Highway 97 / Stickle Road Safety Review FINAL REPORT

McElhanney Consulting Services Ltd.
100-780 Beatty Street
Vancouver BC
V6B 2M1

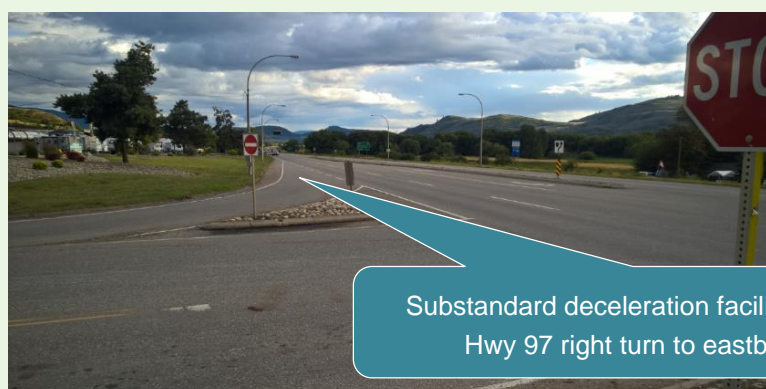
Observation		
Item	Safety Concern	Potential Mitigation Measure
2	Northbound Deceleration Lane The northbound right turn facility from Highway 97 at Stickle Road is a direct taper (i.e. no parallel deceleration lane segment). As a result, there is a risk of northbound rear-end type collisions on the approach to the Stickle Road intersection as well as a risk of northbound right-turning vehicles taking the turn at inappropriately high speeds and crossing the centreline on Stickle Road, resulting in a collision on Stickle Road.	Auxiliary Lanes Provide deceleration lane geometry in accordance with the requirements of the BC Supplement to TAC Figure 710.H Rural Arterial Intersection layout (i.e. 100 m parallel deceleration lane). A northbound deceleration lane will reduce the risk of northbound rear end type collisions, and collisions related to excessive turning speeds to Stickle Road.

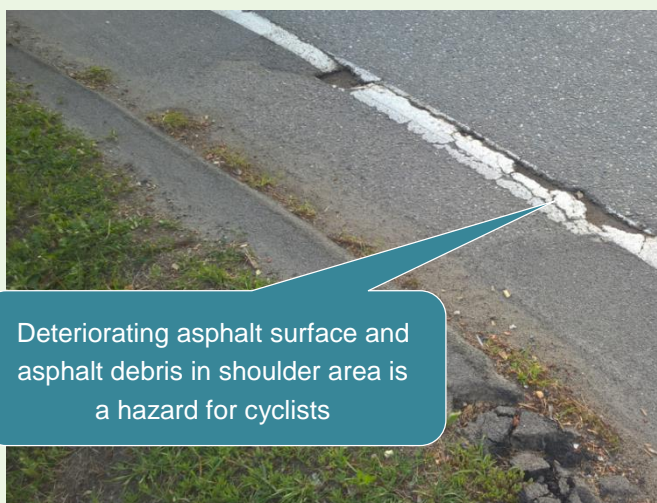
Observation		
Item	Safety Concern	Potential Mitigation Measure
6	<p>Deteriorating Asphalt Surface and Curb</p> <p>Deteriorating asphalt and asphalt curb was observed along the shoulder of the northbound right turn lane. This is considered a hazard for cyclists as it presents unexpected obstacles/uneven surface within the cycling travel portion of the roadway.</p>	<p>Pedestrians / Cyclists</p> <p>Deteriorating asphalt surface should be repaired and asphalt debris removed from shoulders to create a hazard free and even riding surface for cyclists.</p>

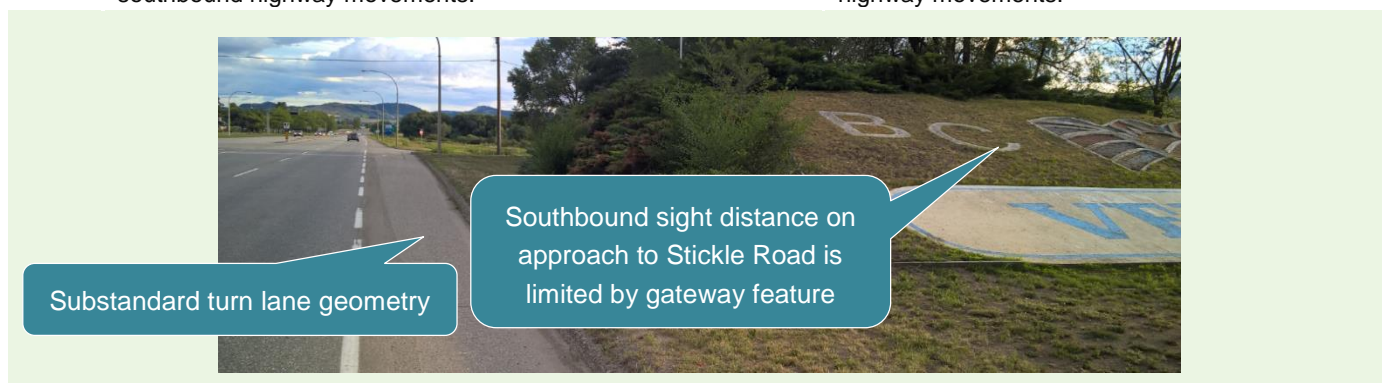
Observation		
Item	Safety Concern	Potential Mitigation Measure
7	<p>Southbound Deceleration Lane and Landscaping</p> <p>The approach to the southbound right turn to Stickle Road westbound has a substandard design: deficient deceleration lane, taper, and lane width. In addition, the west leg of Stickle Road is hidden from southbound Highway 97 vehicles by the landscaped gateway feature entering Vernon. This results in several safety concerns, namely reduced roadside safety through the absence of a standard shoulder (greater risk of southbound right-turning vehicles hitting the asphalt curb), and a reduction in the available turning sight distance for westbound vehicles exiting Stickle Road which may result in conflict with southbound highway movements.</p>	<p>Auxiliary Lanes Sight Distance</p> <p>Provide deceleration lane geometry in accordance with the requirements of the BC Supplement to TAC Figure 710.H Rural Arterial Intersection layout (i.e. 100 m parallel deceleration lane) to improve roadside safety. The landscaped gateway feature should be modified to ensure that adequate intersection and departure sight distance is provided. Providing adequate sight distance from the west leg of Stickle will reduce the risk of collisions between exiting movements and highway movements.</p>

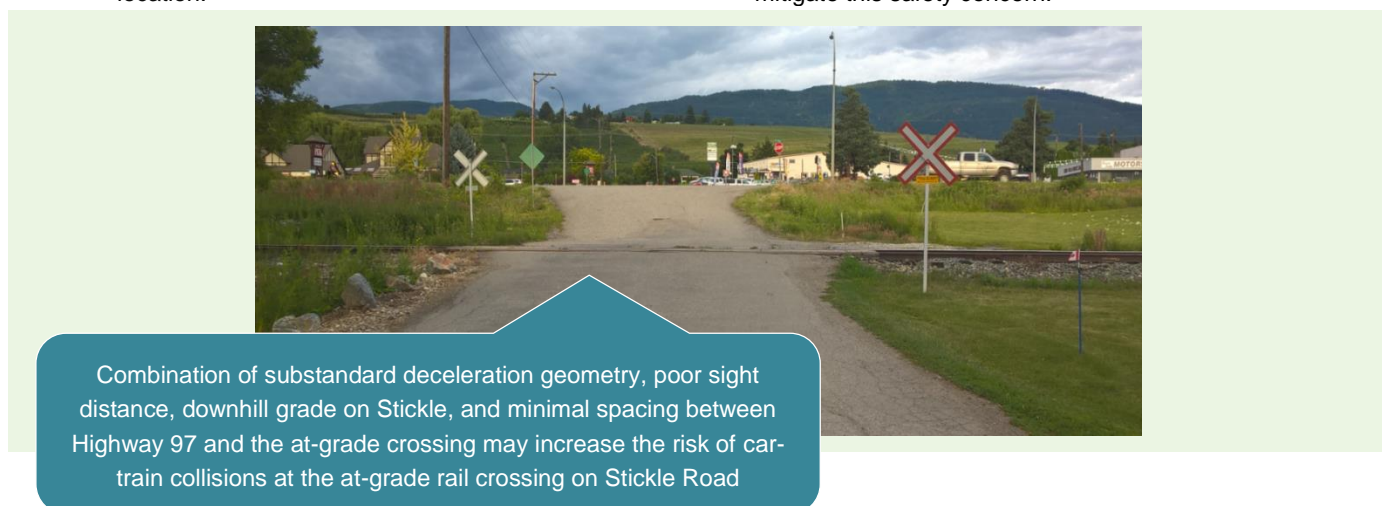
Observation		
Item	Safety Concern	Potential Mitigation Measure
8	<p>At-grade Rail Crossing on Stickle</p> <p>Substandard deceleration geometry for southbound right turning traffic, poor sight distance, minimal spacing between Highway 97 and the at-grade rail crossing, and the downhill grade approaching the at-grade rail crossing (>5%) could result in an increased risk of car-train collisions. Despite this potential risk, we are not aware of any documented vehicle-train incidents occurring at this location.</p>	<p>Rail Crossing</p> <p>At-grade rail crossing lights and bells could be considered in addition to the suggested improvements to the Highway 97 southbound deceleration geometry and sight triangles on the approach to Stickle Road (<i>Item 7</i>). Additional signage on Highway 97 warning motorists of the at-grade crossing should also be considered to improve safety at the at-grade crossing. Signalization is not expected to mitigate this safety concern.</p>

Rock textured raised median

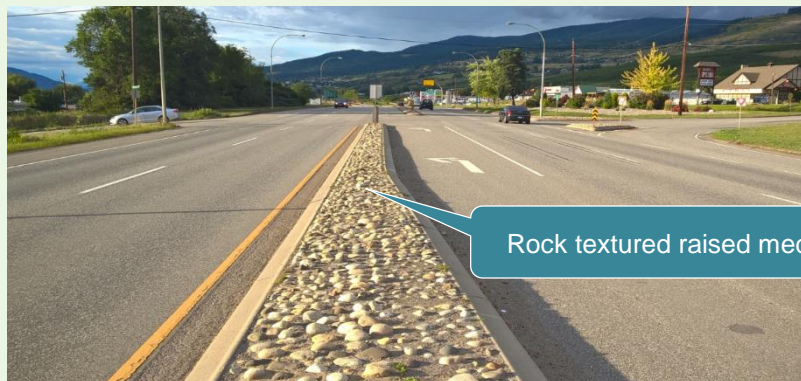
Observation		
Item	Safety Concern	Potential Mitigation Measure
14	Textured Raised Median The existing raised median does not prevent pedestrian crossings, however the rock textured surface presents a tripping hazard for pedestrians that use the raised median as a crossing refuge. Note: Section 180 of the BC Motor Vehicle Act states ' <i>when a pedestrian is crossing a highway at a point not in a crosswalk, the pedestrian must yield the right of way to a vehicle</i> ', and so pedestrians are permitted to cross Highway 97 at Stickle Road under this condition.	Pedestrians / Cyclists Consideration should also be given to better accommodating pedestrian/cyclists crossing movements within the Restricted Left option. This may include an informal pedestrian median refuge to improve pedestrian crossing safety. An informal refuge is suggested as pedestrian movements should not be encouraged at this location (due to high vehicle travel speeds). A formal pedestrian crossing is not proposed, however signage warning motorists of the presence of pedestrians is suggested. Note to designers: provide smooth median surface to mitigate median tripping hazard observed in existing condition.

Figure 7. Option 1: Signalized Intersection Improvement

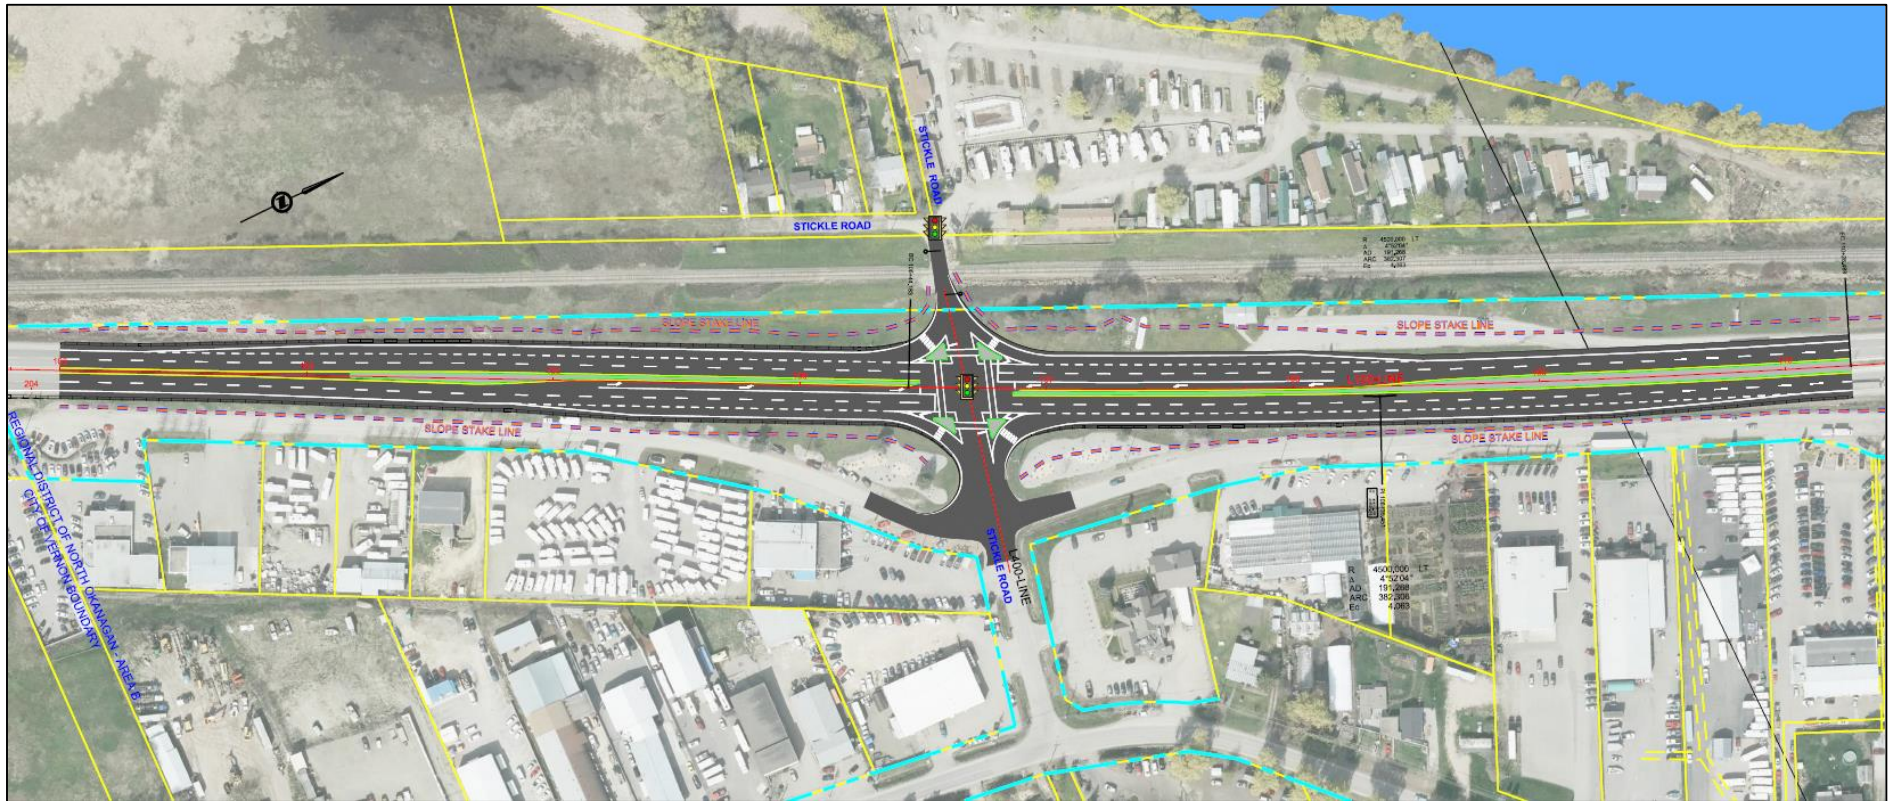
Of the improvement options considered, Option 1, the signalized intersection option is not supported for the following reasons:

- A signal is not warranted
- The introduction of traffic signals on high-speed corridors has been shown to increase rear-end collisions by 243% based on a review of Collision Modification Factors used in road safety analysis
- The signal is not consistent with the North Okanagan-Shuswap Corridor Management Plan
- In future, analysis shows that a signal will result in significant queuing of traffic on the highway, delaying traffic and further increasing the risk of collisions
- The introduction of a traffic signal will trigger the need for a warning system with gates at the adjacent rail crossing based on a review of Transport Canada Grade Crossing Standards (assumes public rail crossing with rail design speed 25 km/hr or greater)

Figure 8. Option 2: Restricted Side Road Left Turn and Through Movement Intersection Improvement

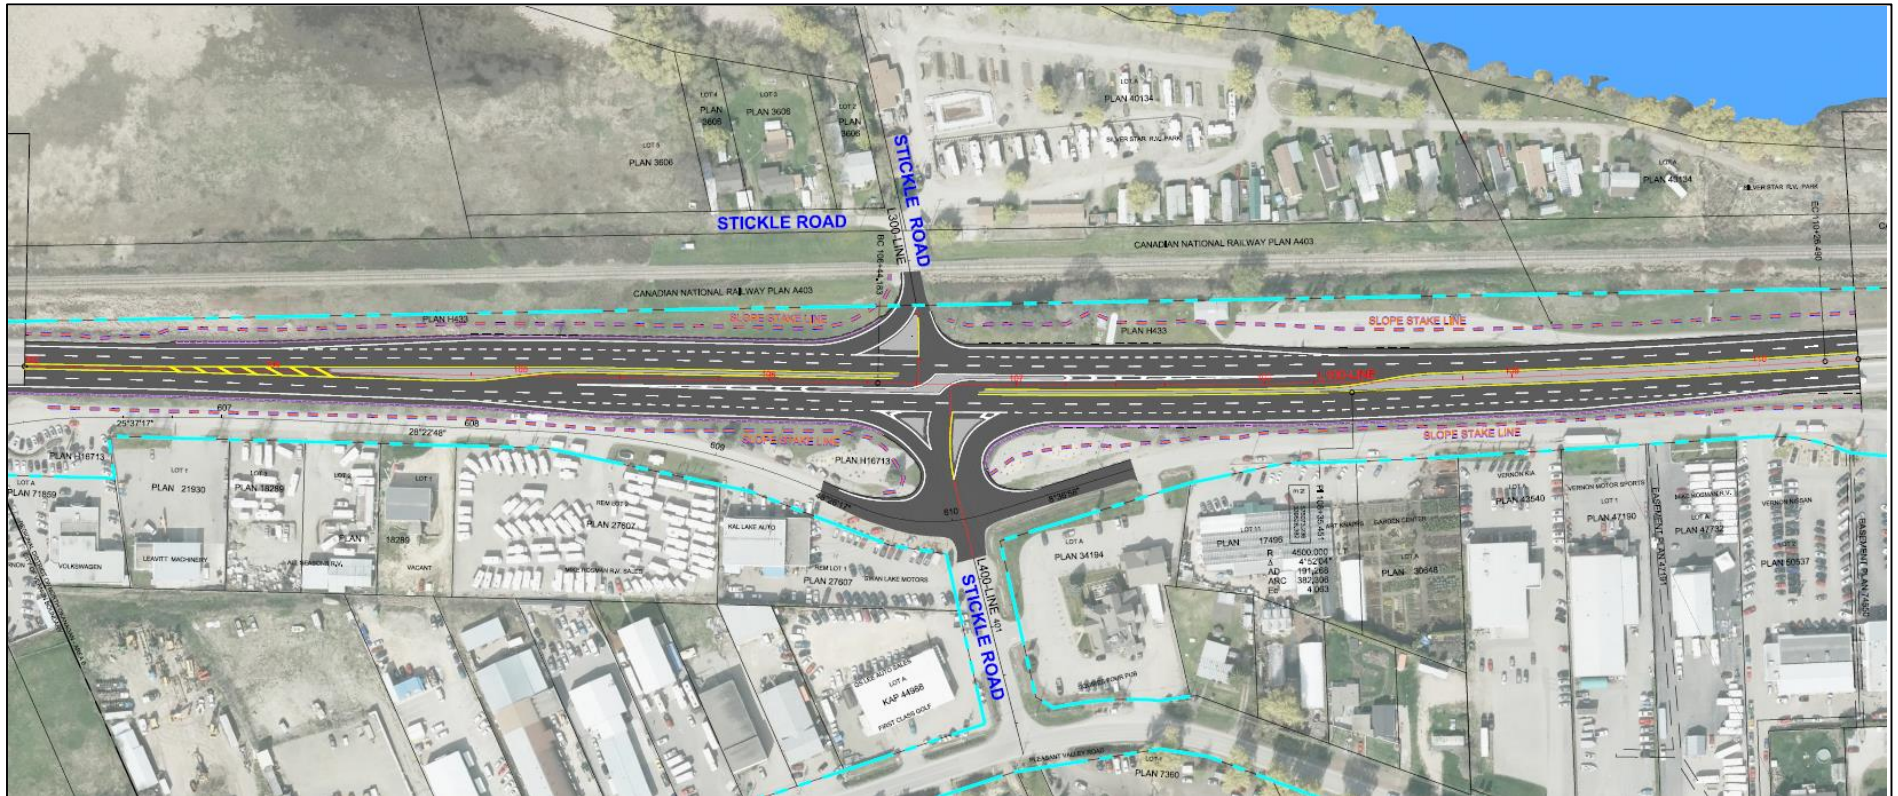
Due to the restriction of the existing westbound left turn movement at Highway 97/Stickle Road if Option 2 is implemented, and to reduce the impact of this movement restriction on Pleasant Valley Road, the City of Vernon and the Regional District of North Okanagan propose to extend the Frontage Road south to 20th Street as an alternative route. A one-way southbound connection is planned.

This proposed connection is supported; however, it is recommended that a two-way roadway be provided for the following reasons:

- There is a safety risk that inattentive drivers, having used this road in the southbound direction, will assume it also serves the northbound direction, thereby raising the risk of a collision with unsuspecting southbound drivers.
- The existing Frontage Road is two-way, and changing the cross section to one-way further south is confusing for motorists.
- The additional two-way link, together with Pleasant Valley Road, will provide highway redundancy in the event of a highway closure.
- The connection enables a reduction in local traffic demand on the highway between Vernon and Stickle Road.

Option 2, the restricted side road left turn and through movement intersection improvement option which prohibits left turns out of Stickle Road and east-west through movements, is supported for the following reasons:

- It maintains the free-flow north-south movement of traffic on Highway 97, which movements account for approximately 95% of the total traffic volume entering the intersection, thereby eliminating queuing and delay at this intersection
- It is consistent with North Okanagan-Shuswap Corridor Management Plan
- It increases safety at the intersection by significantly reducing the number of vehicle conflicts
- The restriction of the left turn movement from Stickle Road onto Highway 97 is accommodated by both the 20th Street connection, as well as Pleasant Valley Road network links
